SWIM PROJECT PROFILE

SWIM PROJECT PROFILE		File No. : 1
Regist. No. : Agency No. : DPWH-1	Name: SAYTAN DAM & RESERVOIR SWIP	
Region: 1	Province: LA UNION	Municipality: SAYTAN, PUGO
Present Status: 1. Pre-F/S() ② F/S(1983) ③ D/D(-)		
Purpose: Major : Irrigation Incidental : IF, FG, MH		
Project Feature:

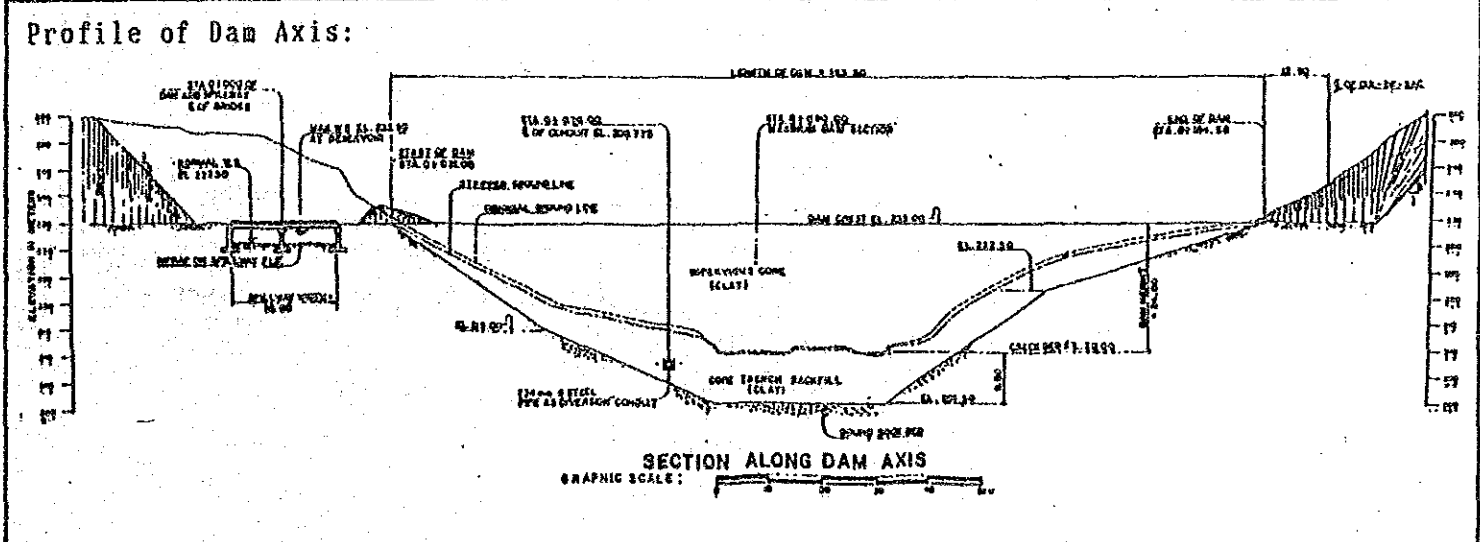
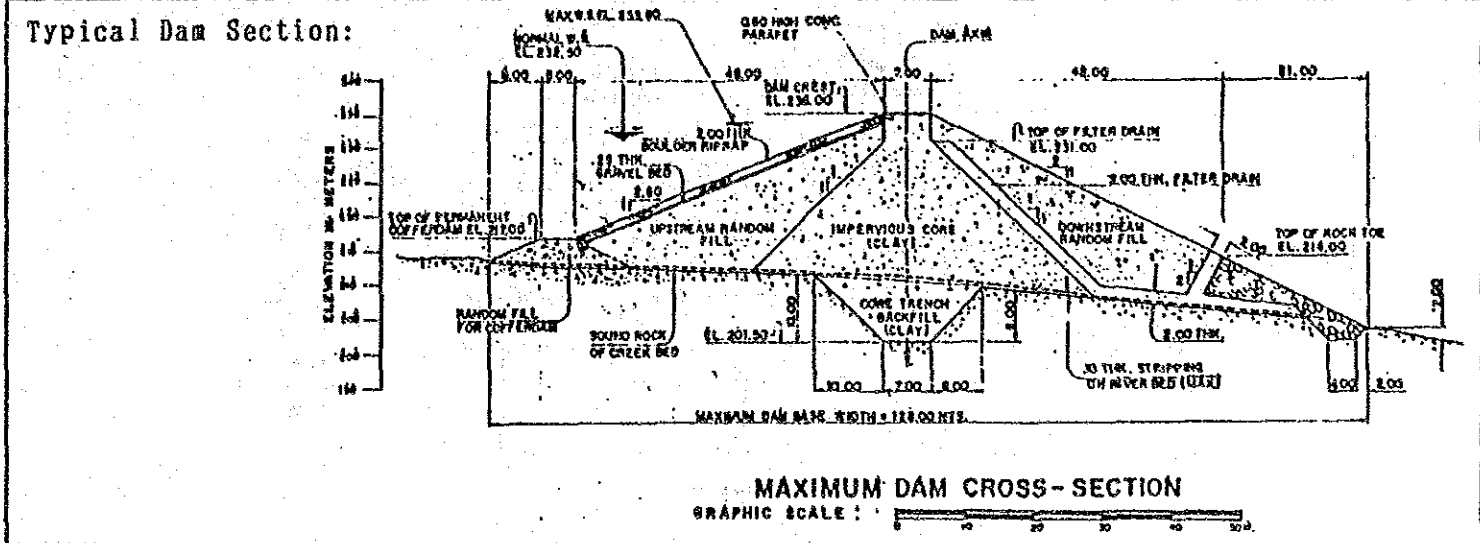
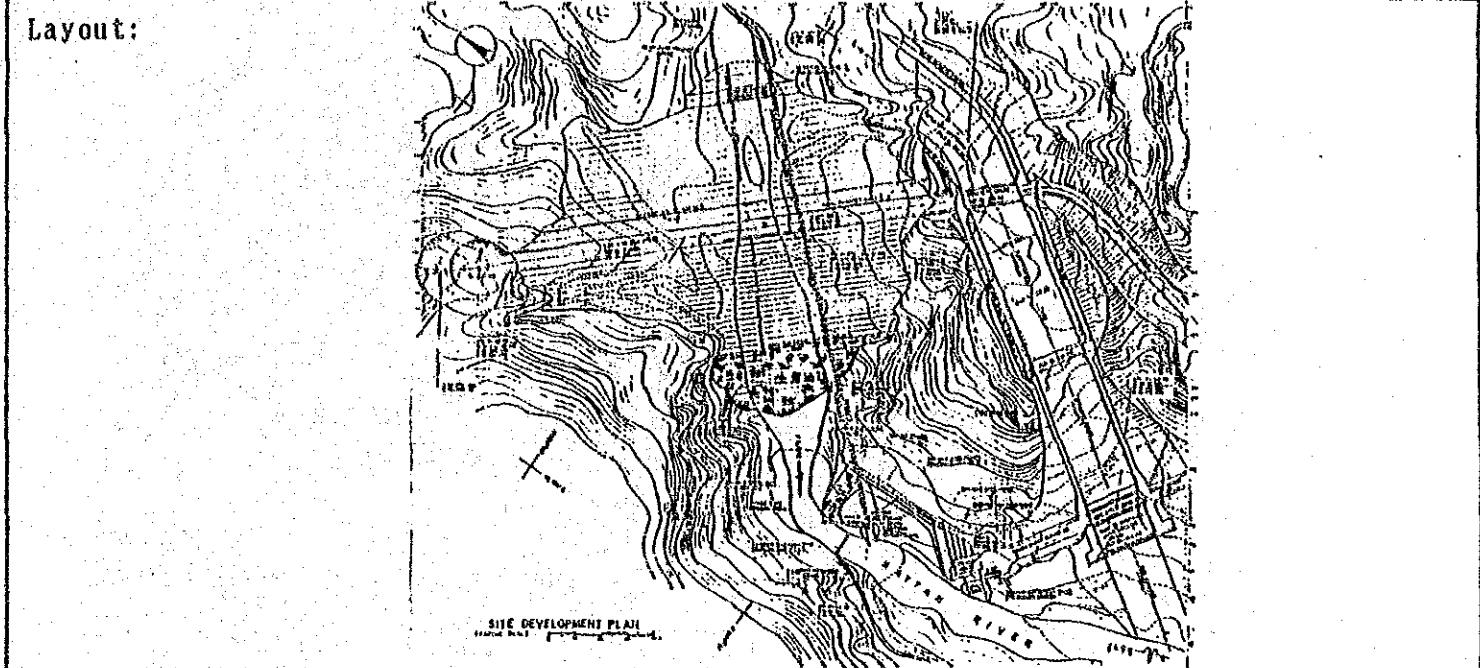
6. Inland Fishery	Annual Production : 5 ton/year	
Technical Assessment:		
1. Survey and Investigation: Geological structure shall be clarified besides bearing capacity and permeability. Quarry site of filter material in zoning shall be investigated. Soil mechanical test for the dam embankment materials shall be carried out.

2. Planning Mini-hydro. benefit and annual production of inland fishery are over-estimated. Project planning shall be re-formulated.		
3. Design Form and depth of core trench should be decided after investigation of the dam foundation. In case of rock foundation, grouting works is necessary to prevent the percolation through cracks in the foundation. Some design modification of spillway and outlet works are necessary.

Note:
The foundation material is assumed to be impervious.

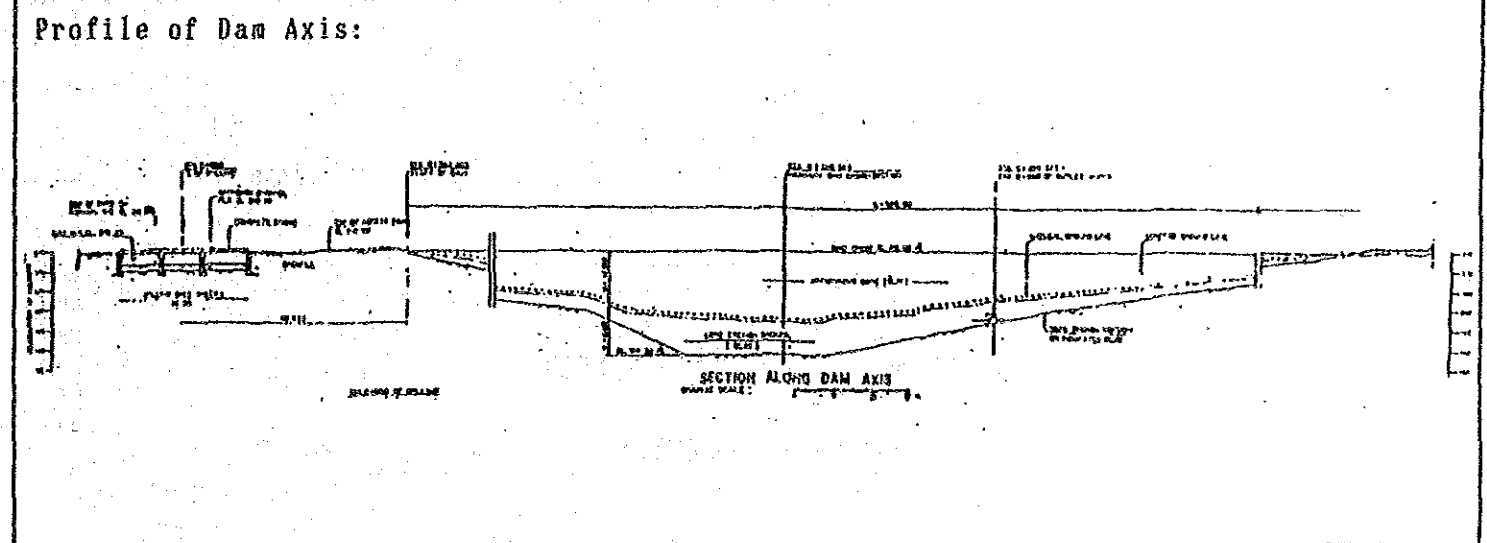
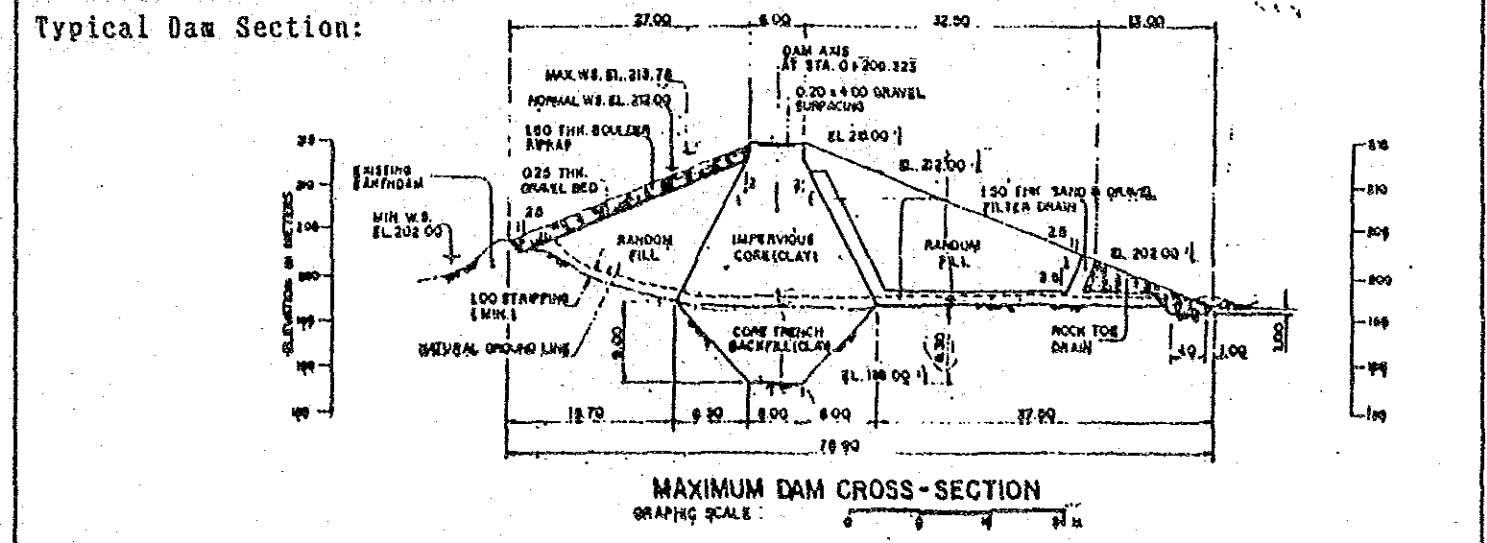
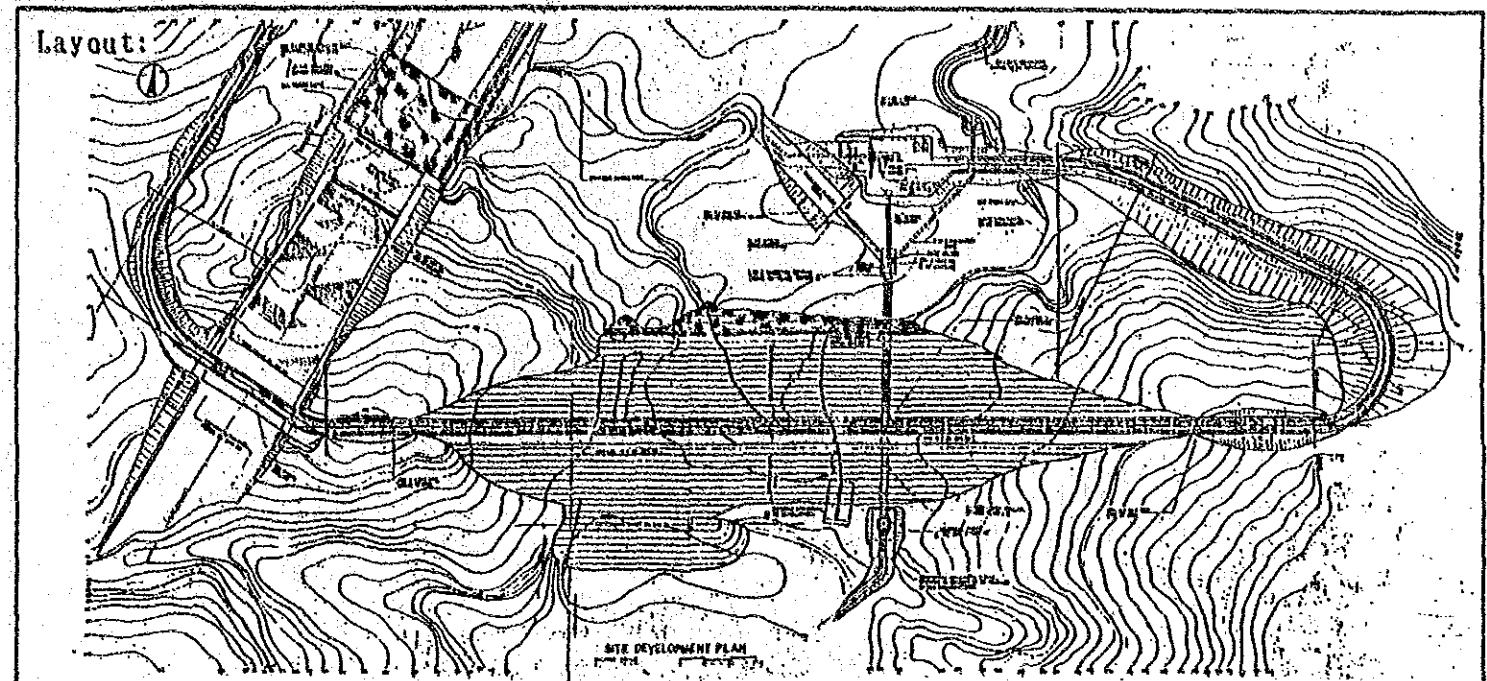
6. Inland Fishery	: Annual Production	: 42 ton/year
Technical Assessment:		
1. Survey and Investigation: Permeability and bearing capacity of the dam foundation shall be measured. Soil mechanical test for the dam embankment shall be conducted. Excavation materials of the spillway can be used for the dam embankment.

2. Planning Mini-hydro benefit and annual production of inland fishery are over-estimated.		
3. Design Inlet of the outlet works is recommended to be located outside of the dam embankment. Width of the supercritical flow section is recommended to be uniform.

Note:
The foundation is assumed to be relatively impervious ($K < 10^{-5}$ cm/sec) underlying the river story deposits with 4.3 m depth, which is suitable against percolation.

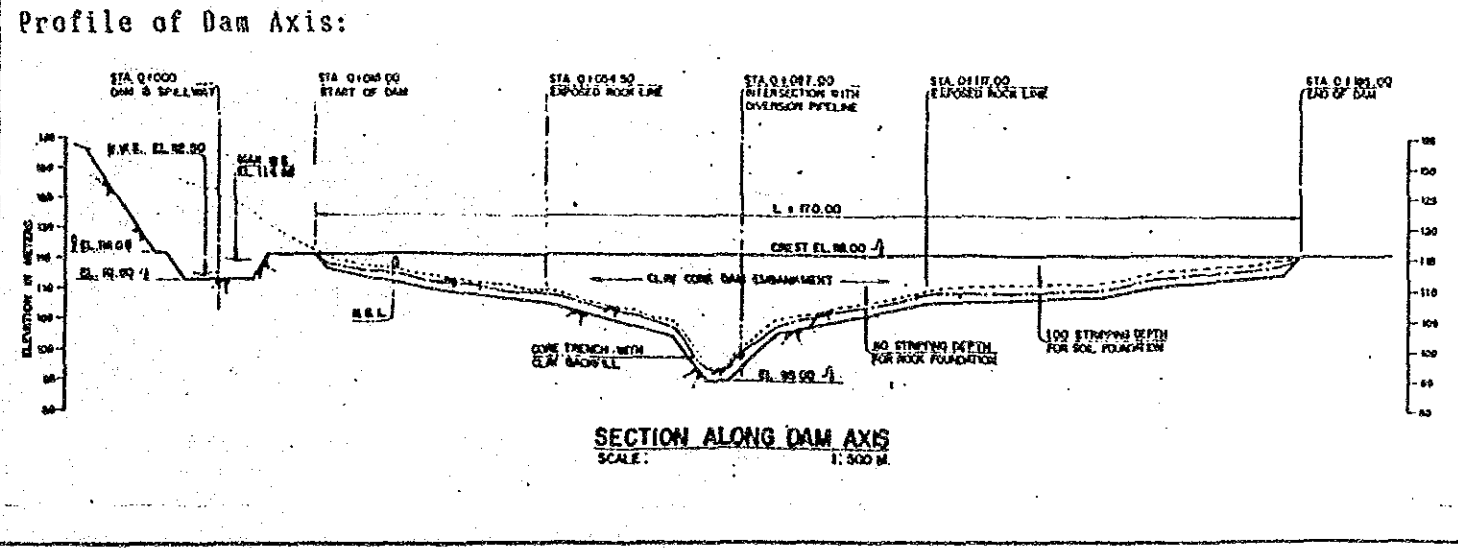
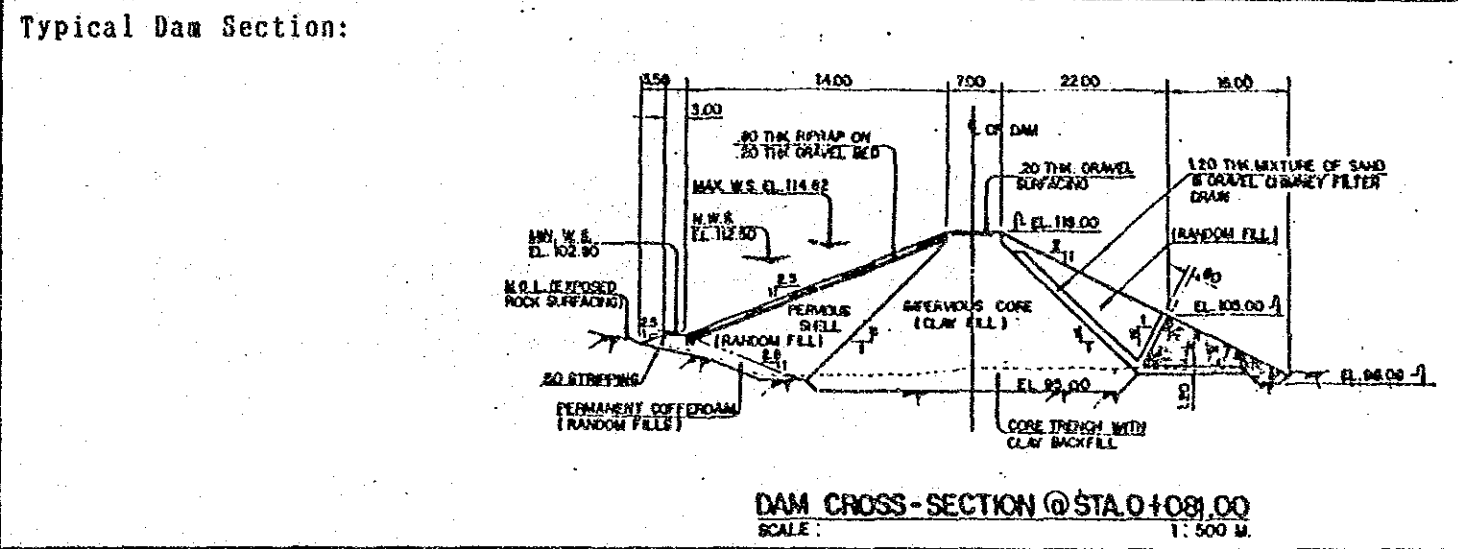
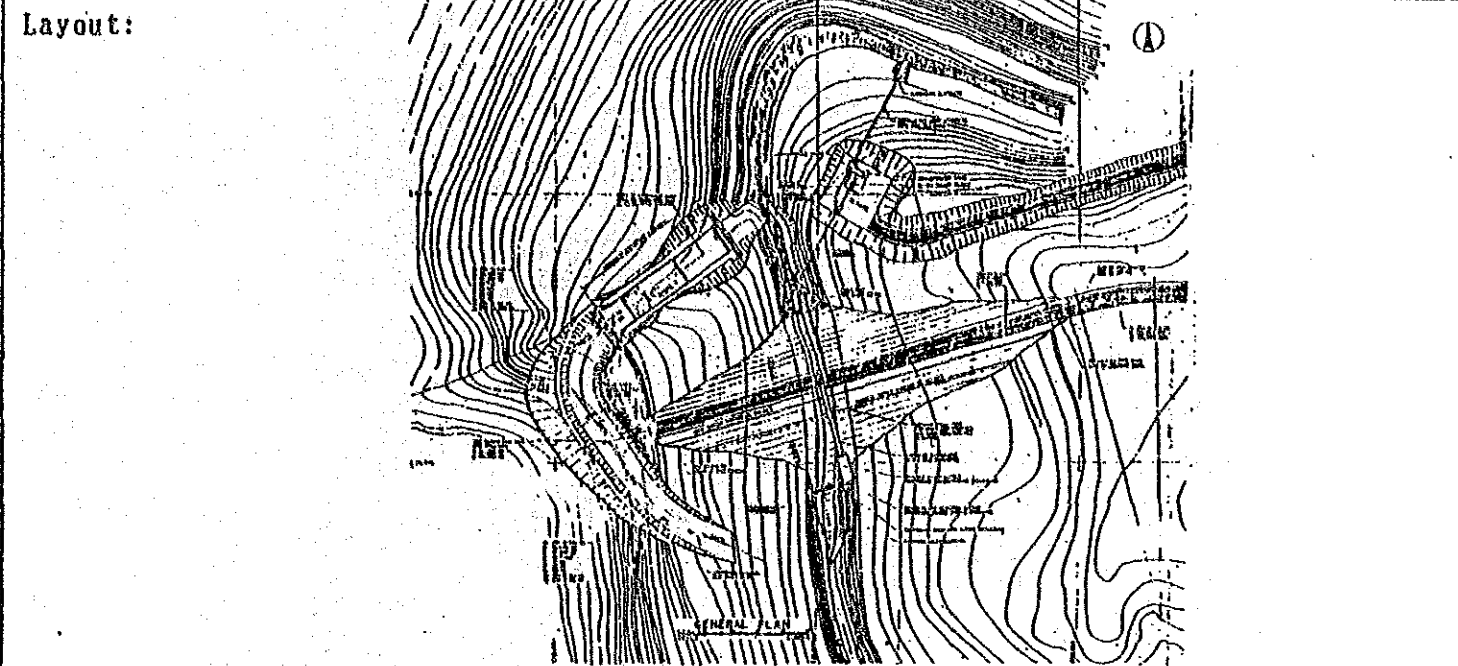
6. Inland Fishery	Annual Production : 8 ton/year	
Technical Assessment:		
1. Survey and Investigation: Scale of topographic map for the dam site shall be more than 1/500. No permeability test is conducted. Available volume for the dam embankment shall be estimated before construction.

2. Planning Water distribution system in water supply plan is not formulated. Annual production of inland fishery is over-estimated. Watershed management plan is not formulated. Project planning shall be re-formulated.

3. Design Excavation line near the river bed shall be slightly changed to avoid differential settlement. Blanket grouting in the outcropped river bed is required to prevent the percolation in the foundation. Pier of bridge for access to the tower shall be planned on the natural ground. Diversion discharge is not mentioned.

Note:
Slope of excavation line near the riverbed shall be changed to be moderately (additional excavation volume is about 23,000 m³). Grouting under blanket (grouting length is about 350 m) is necessary.

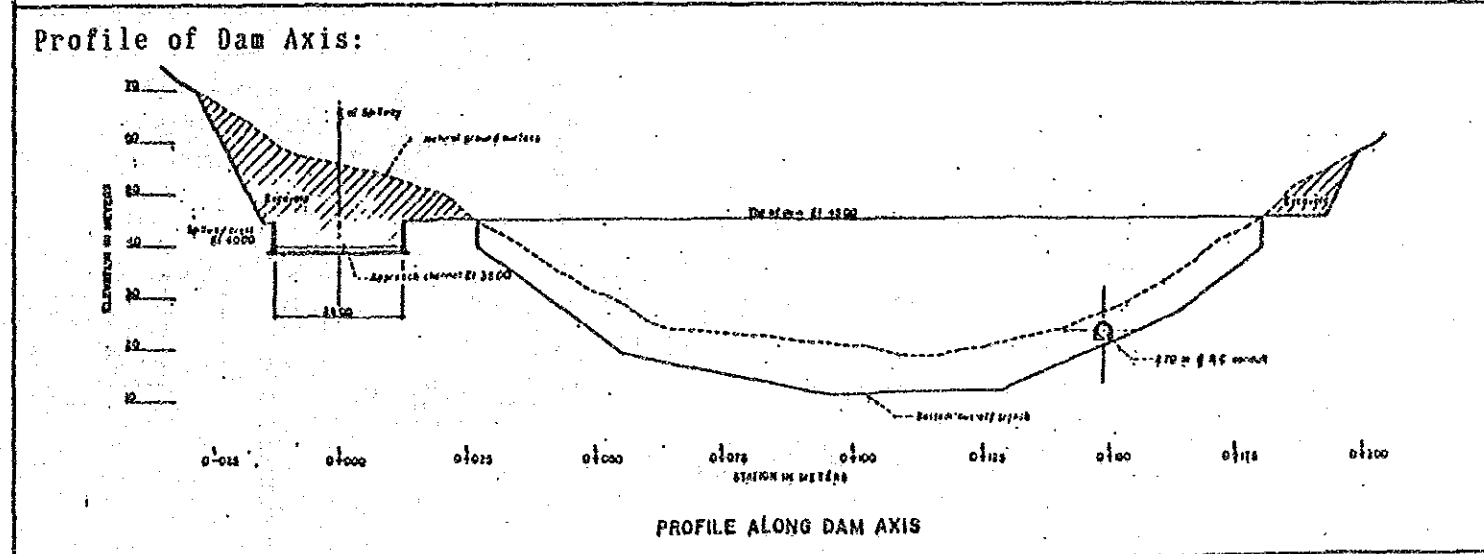
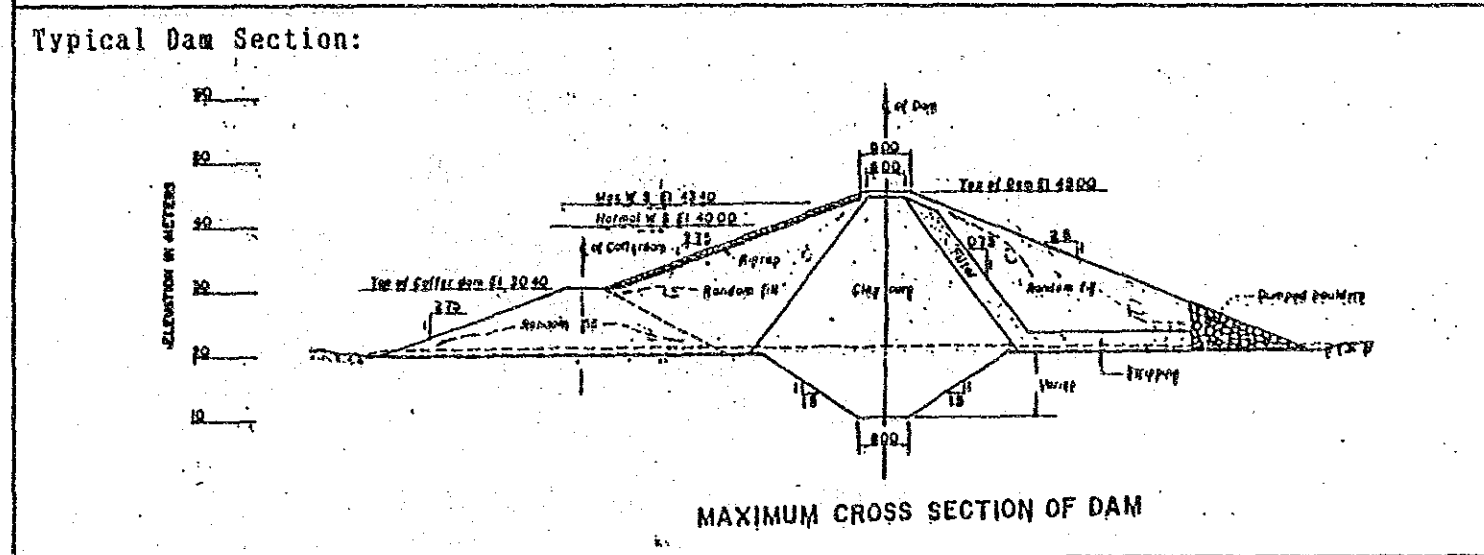
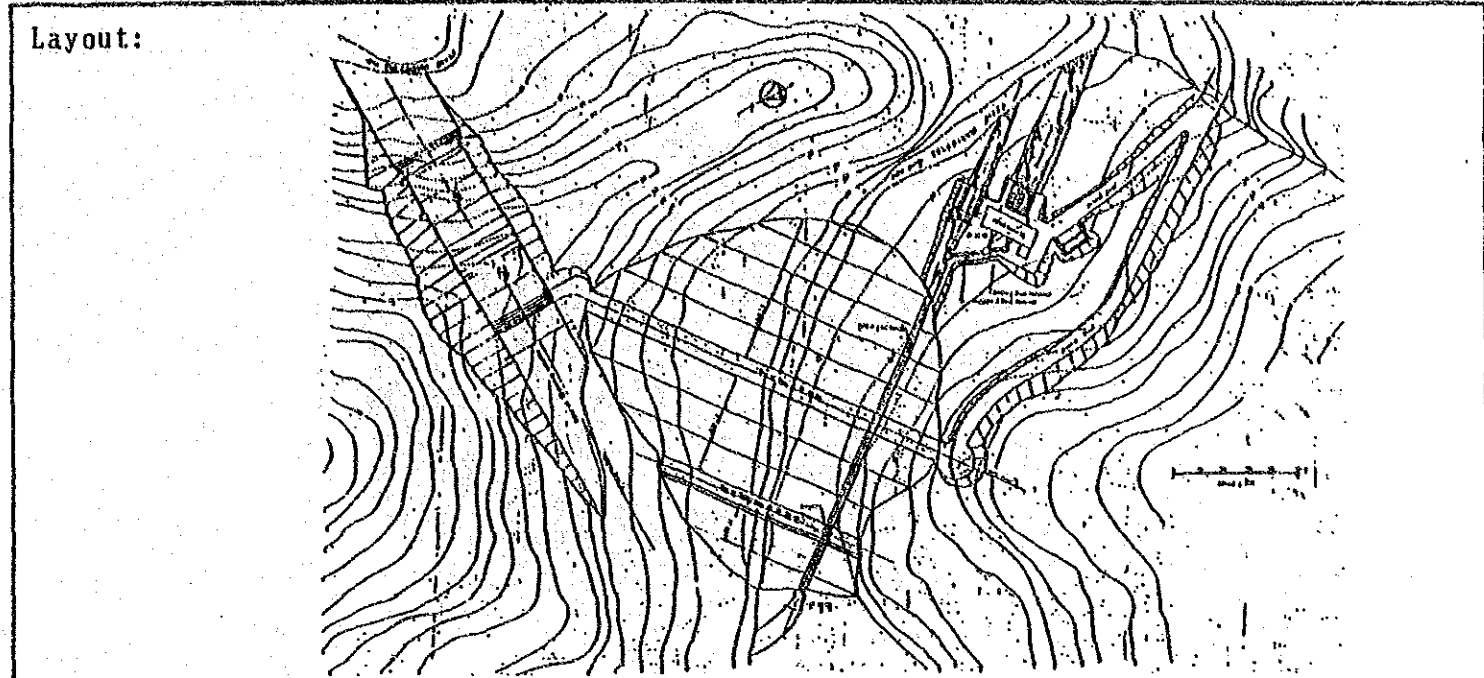
6. Inland Fishery	Annual Production : 46 ton/year	
Technical Assessment:		
1. Survey and Investigation: Scale of the topographic maps shall be more than 1/500 for the dam site and 1/2,000 for the reservoir site. Additional boring is necessary for bearing capacity in sandy silt layer. Soil mechanical test for the dam embankment materials shall be conducted. Subsurface investigation is not enough for alluvium stratum.

2. Planning Mini-hydro. benefit and annual production of inland fishery are over-estimated. Watershed management plan is not formulated. Project planning shall be re-formulated.

3. Design Drainage of seepage water in core trench is difficult in proposed 10 m depth. Inlet of outlet works is recommended to be located in outside of the dam embankment.

Note:
Grouting under core trench in case of trench depth being less than 5m, and cut-off upstream in case of trench depth being more than 5m are recommended for sound construction.
(Grouting length=4,500m, excavation volume for upstream=38,400 m³)
